Permit Application Review Report
Date: 6/4/2025

Project Name: Bunker Hills Regional Park Redevelopment

Project PAN: P-24-062

Recommendation: Approve with 2 Conditions and 4 Stipulations

Table 2: Volume Management

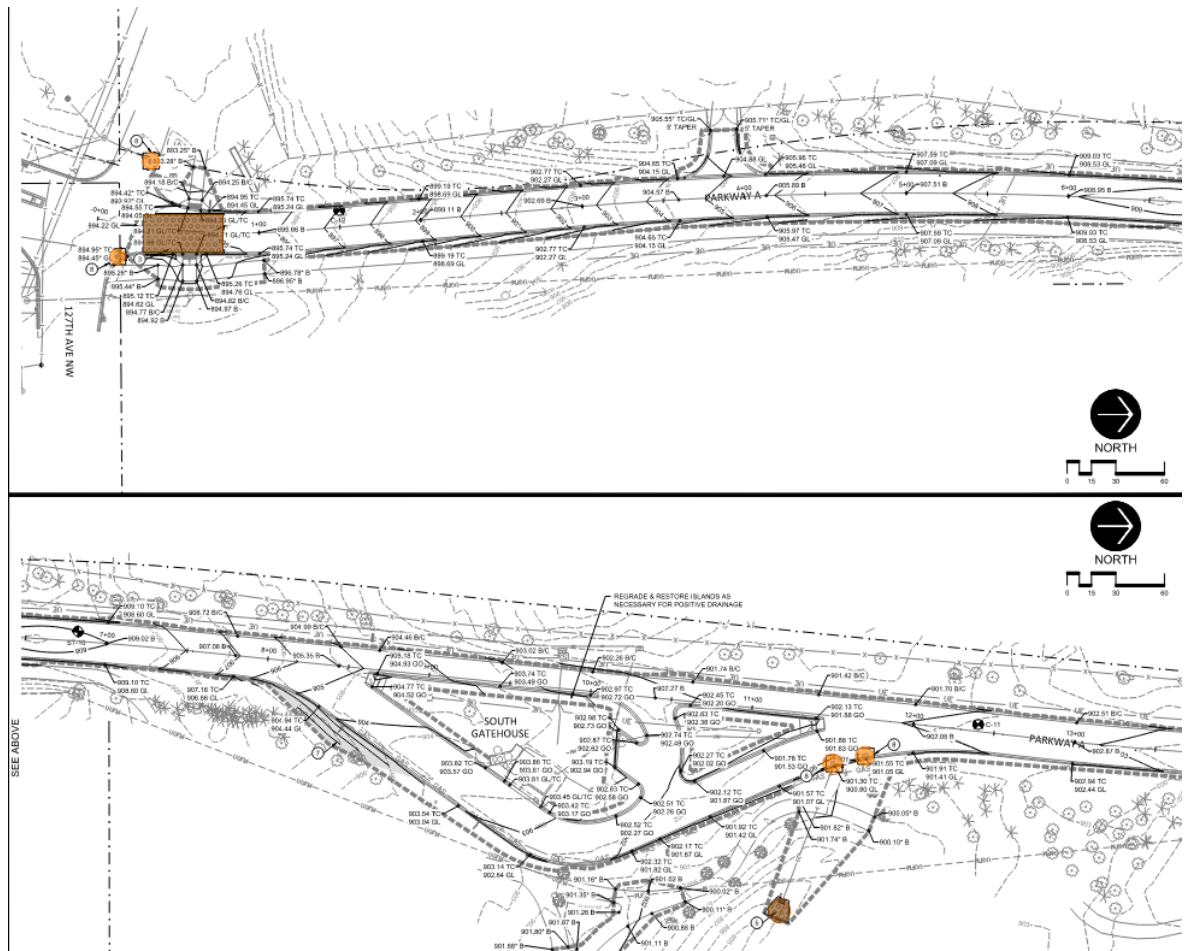
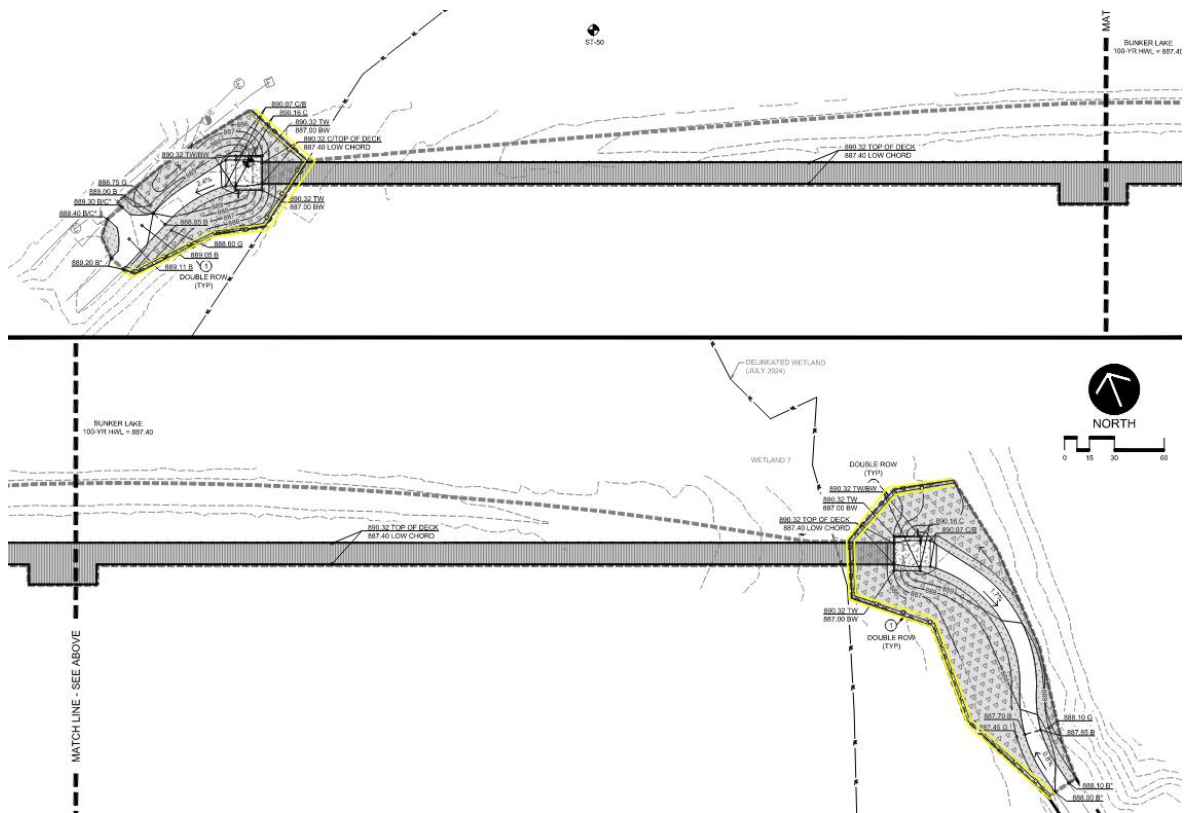
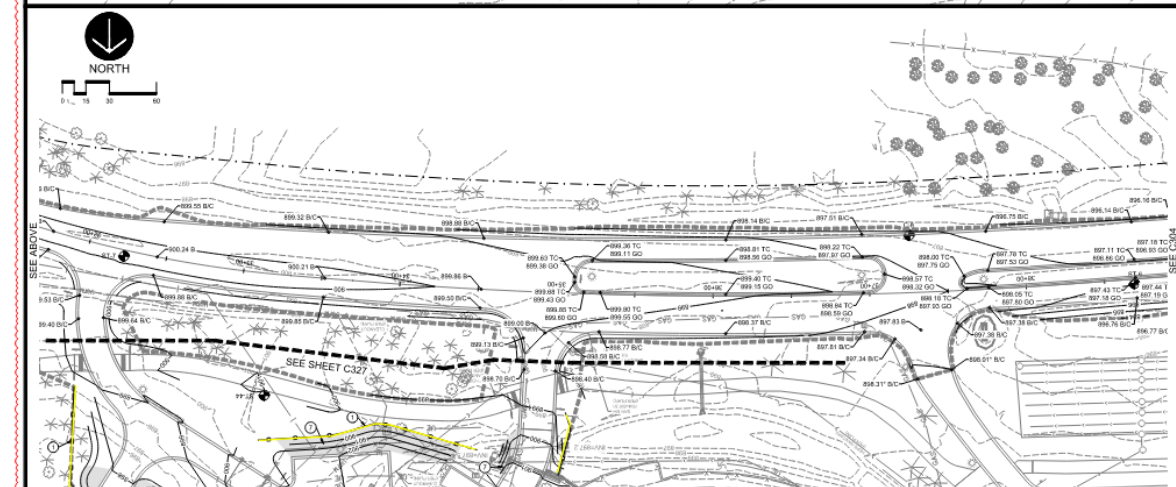
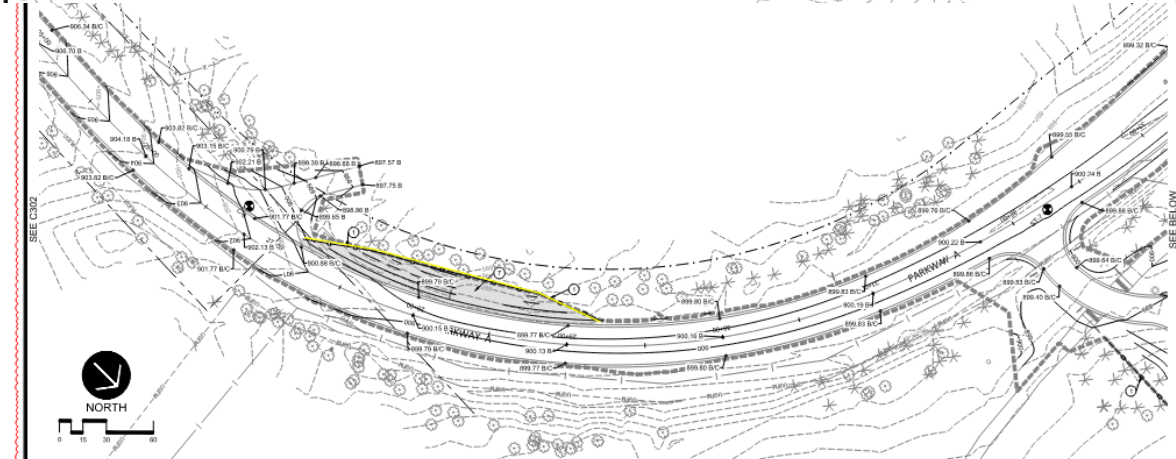
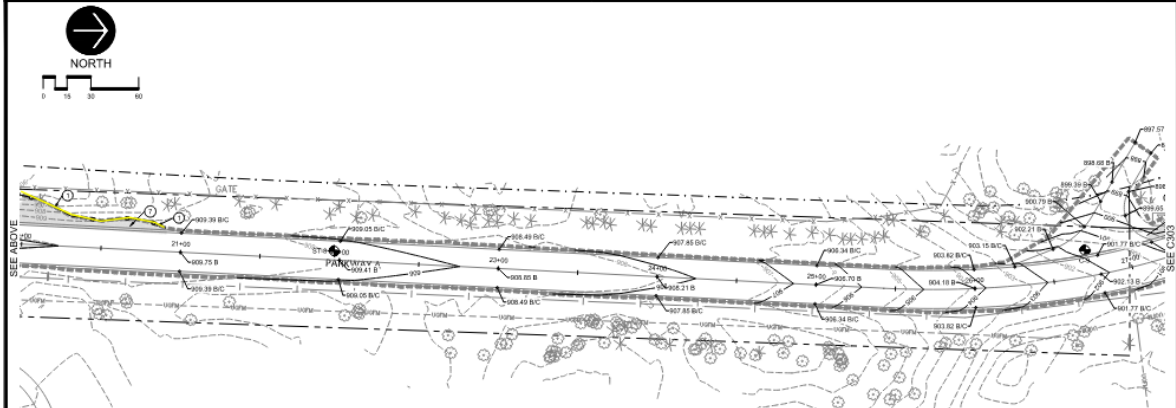
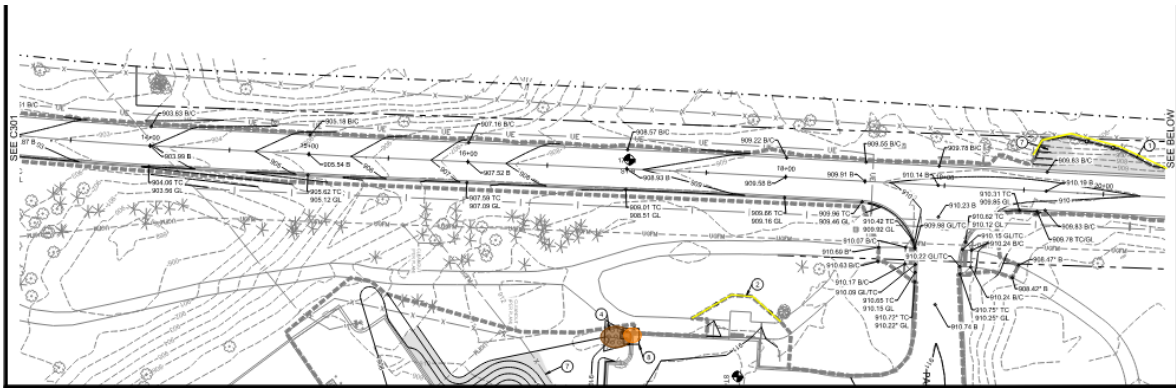
Volume Control: The application proposes redevelopment of existing impervious surfaces. The amount of proposed impervious required to be treated is 143,103 ft². See attached **Table 2.** Volume Control. Note that basin 3A and 3B are undersized, but they flow into basin B3 which makes up for that volume.

The applicant is required to treat 143,103 ft² of new/reconstructed impervious. They are treated 73,017 square feet of the new/reconstructed impervious. The remaining 70,086 square feet of untreated new/reconstructed impervious is made up with in-kind treatment of 136,715 square feet, which exceeds the required amount.

Figure 1: Project Location

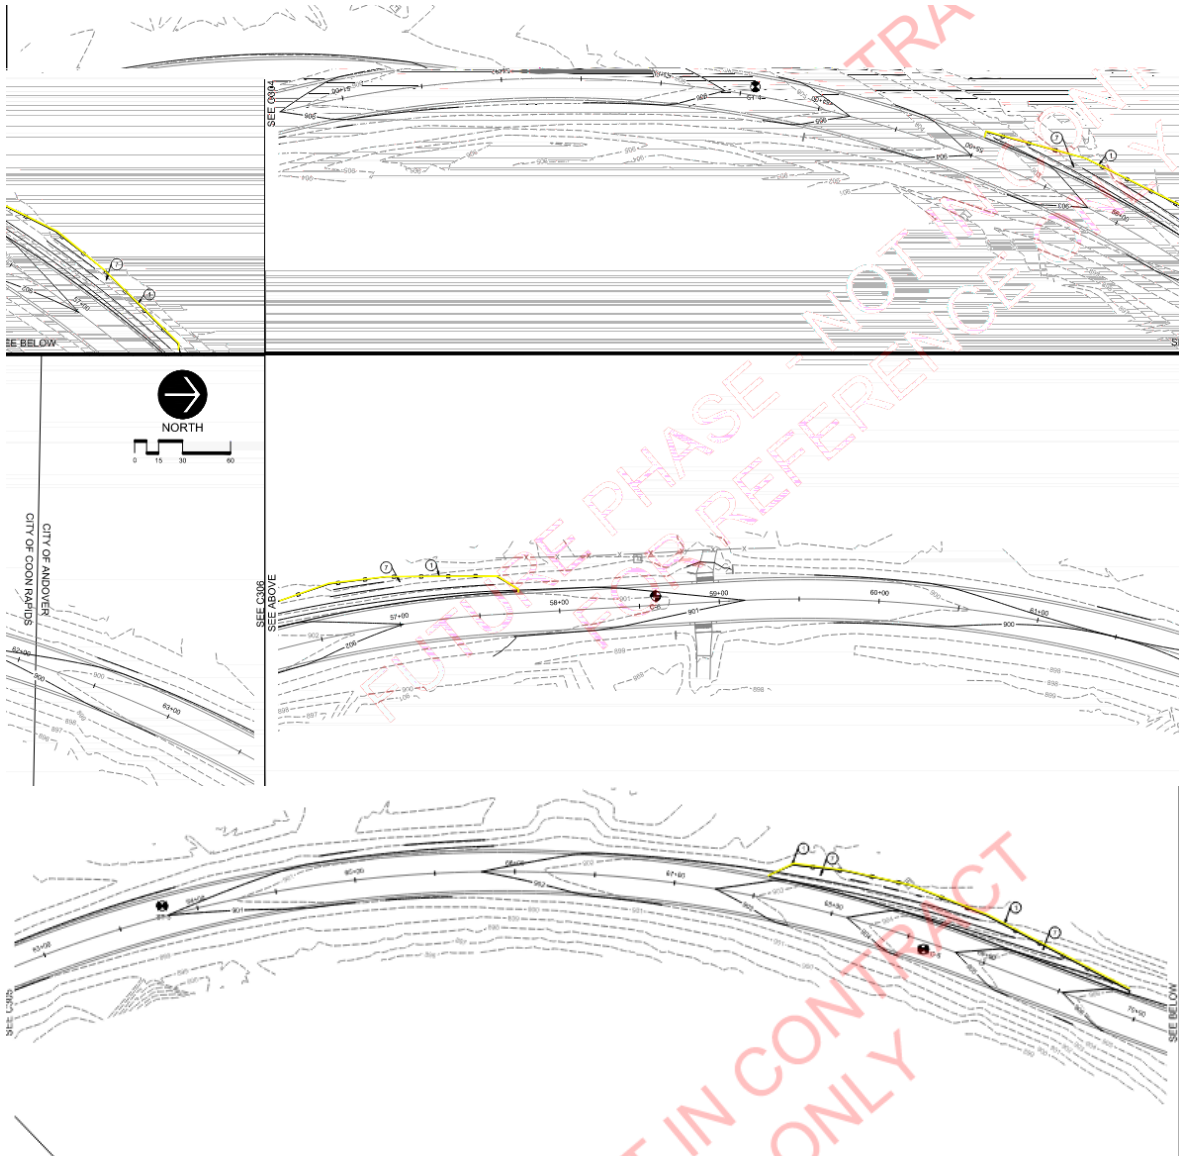
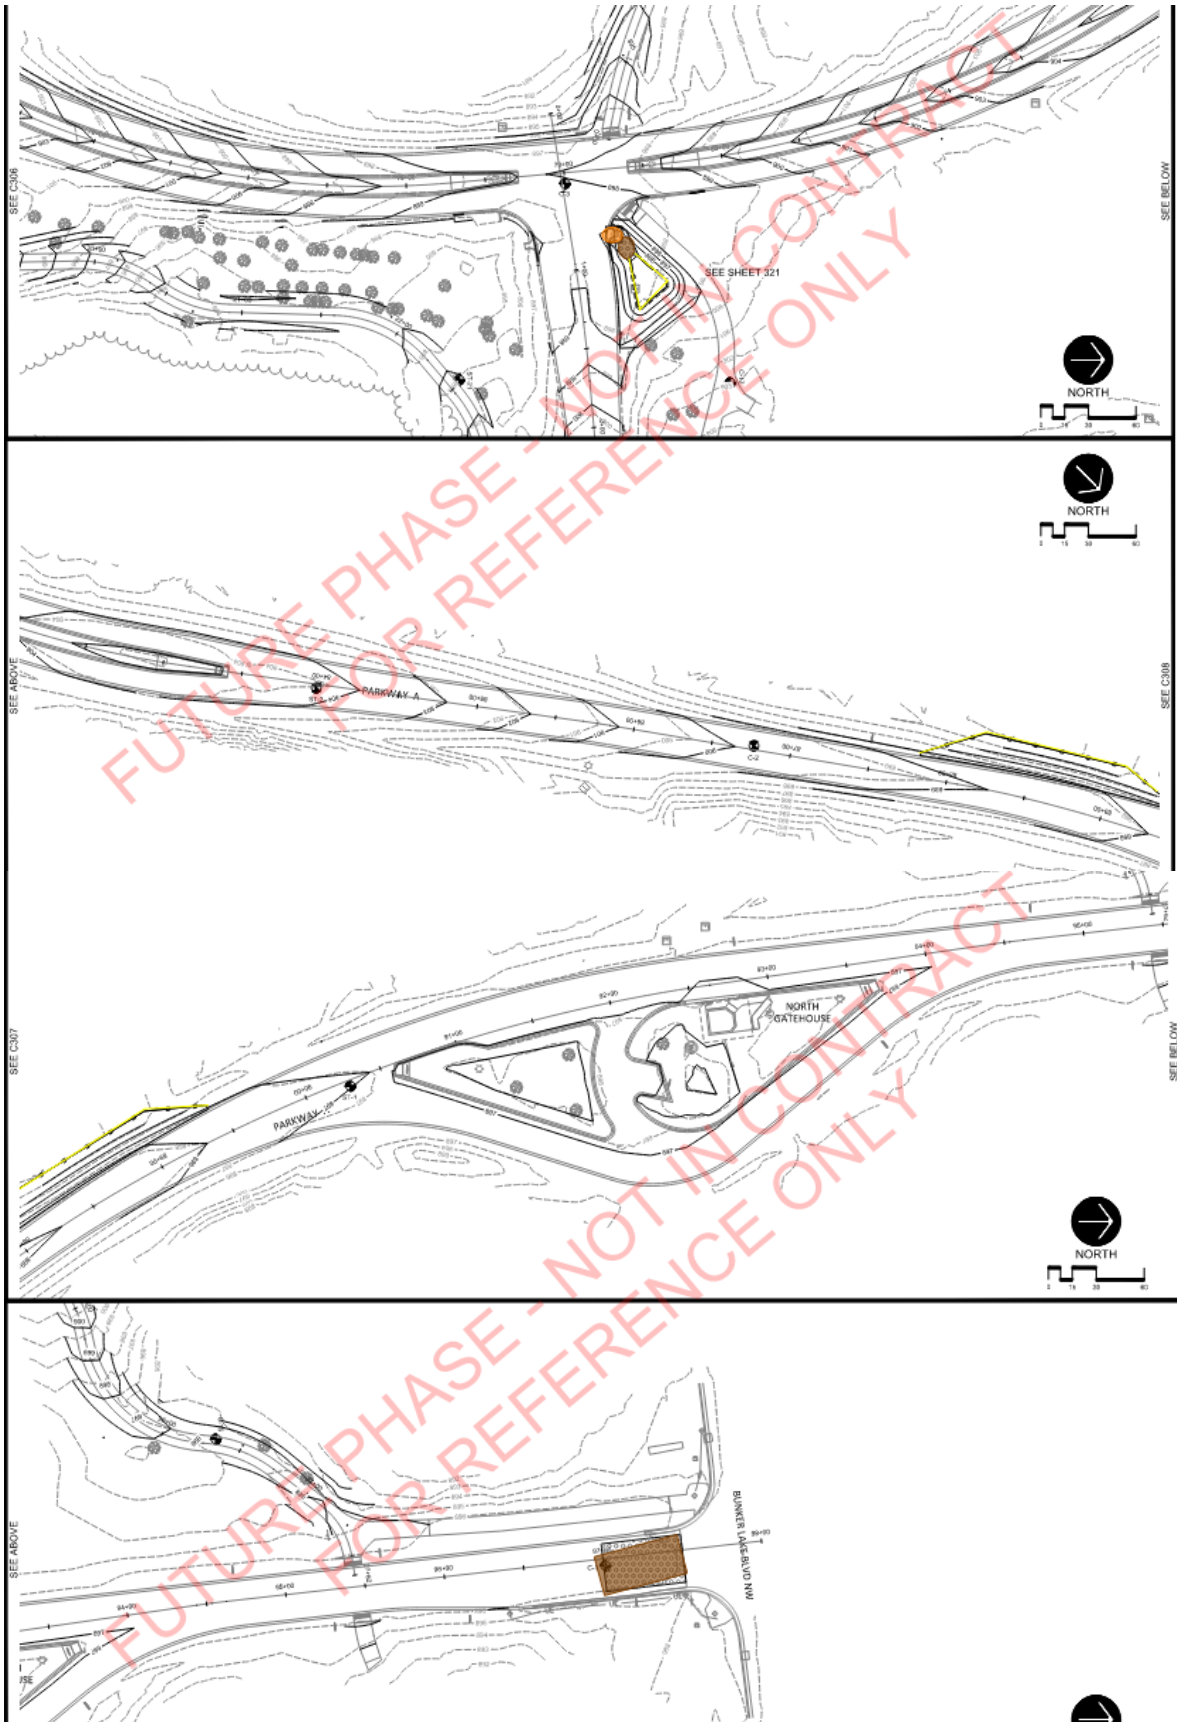
Description: Anoka County Parks proposes the reconstruction of various roadways, parking areas, boardwalk, and trails with utility work and construction of stormwater management features. The project will disturb 27 acres and create 3.28 acres of regulated impervious surface. The southern portion of the project drains to County Ditch 54, the northeast portion of the project drains to County Ditch 23 and the northwest portion of the project drains to County Ditch 57. The relevant water resources concerns are stormwater management, erosion and sediment control, and floodplain. These correspond to District Rules 3, 4, and 6. See attached Figure 1: Project Location.
